project  
Black Country Retrofit Wrap and Associated Works  
100 - 122 Darlaston Road, Kings Hill, WS10 7SR

title  
Section X-X

job	dwg no	rev	date	Aug 20
18-1540	505	A	scale drawn	1:50 @ A3 RP

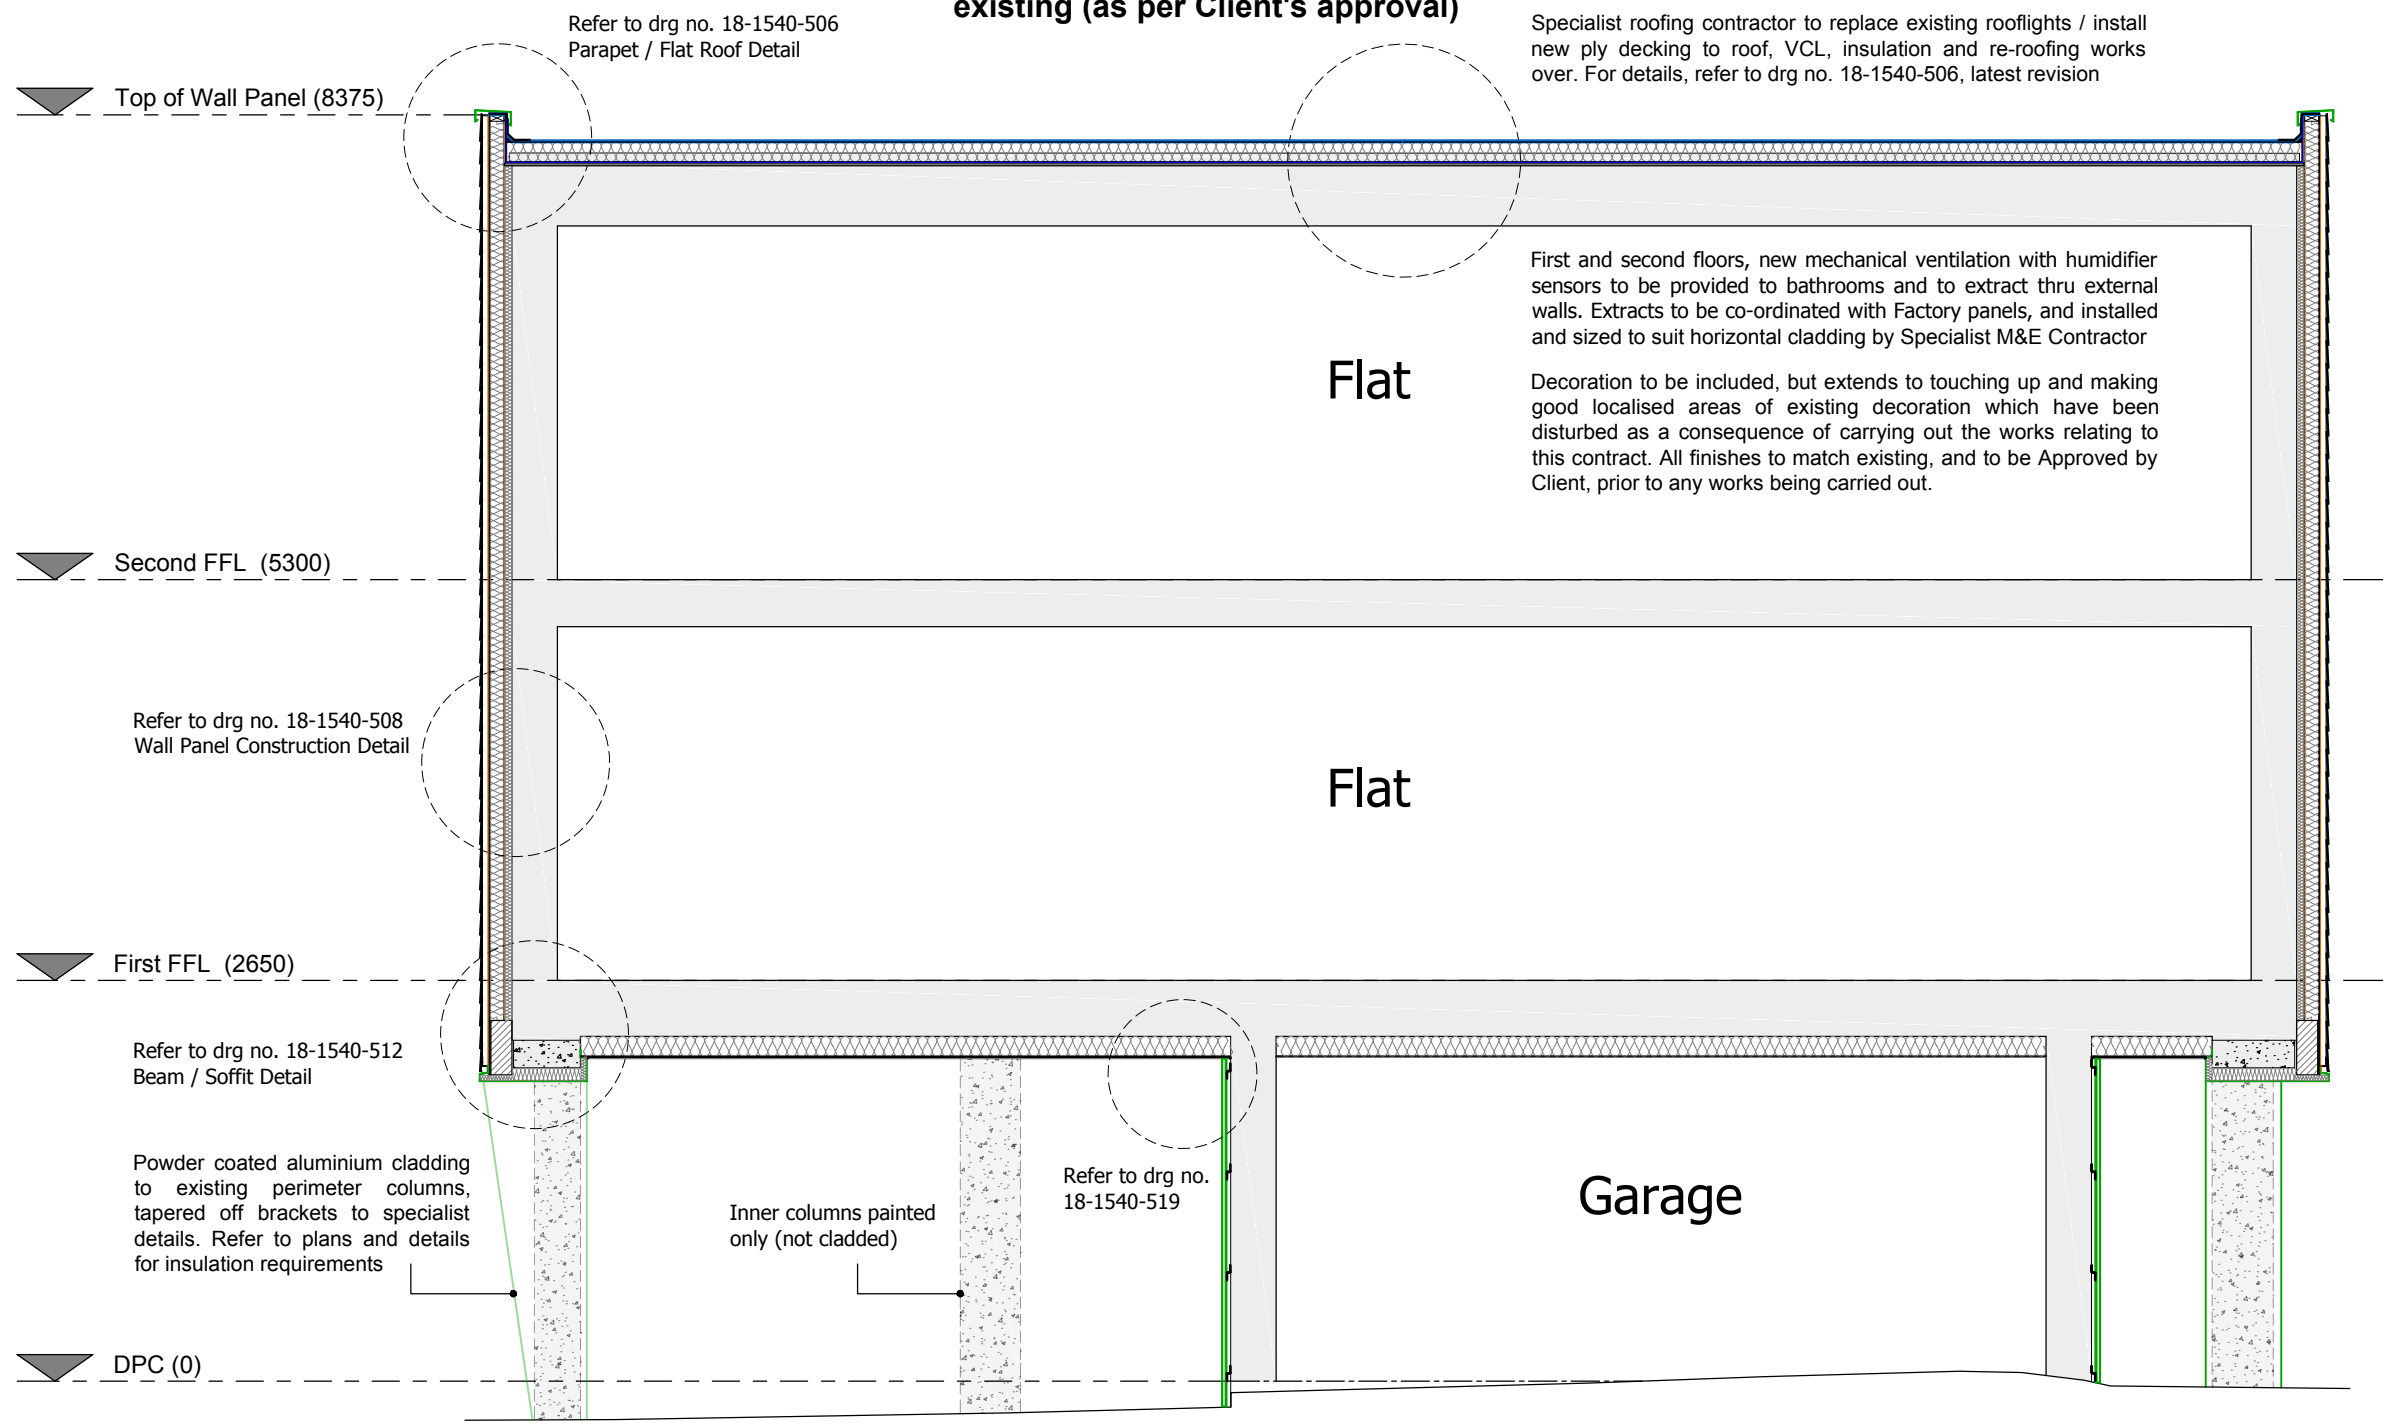
A Notation revised to confirm replacement of roof lights and mechanical ventilation thru walls 25/09/20 RP

**4no. existing roof lights to be replaced with new to match existing (as per Client's approval)**

Roof specialist to ensure new roof lights meet Building Regulation requirements, and allow the roof to achieve the overall average U-Value requirement in accordance with SAP calculations. Roof lights to be triple skin polycarbonate to meet BR compliance, with 150mm upstand (raised kerb) to specialist details. Specialist roofing contractor to undertake works as necessary to seal / waterproof around the new roof lights.

First and second floors, new mechanical ventilation with humidifier sensors to be provided to bathrooms and to extract thru external walls. Extracts to be co-ordinated with Factory panels, and installed and sized to suit horizontal cladding by Specialist M&E Contractor
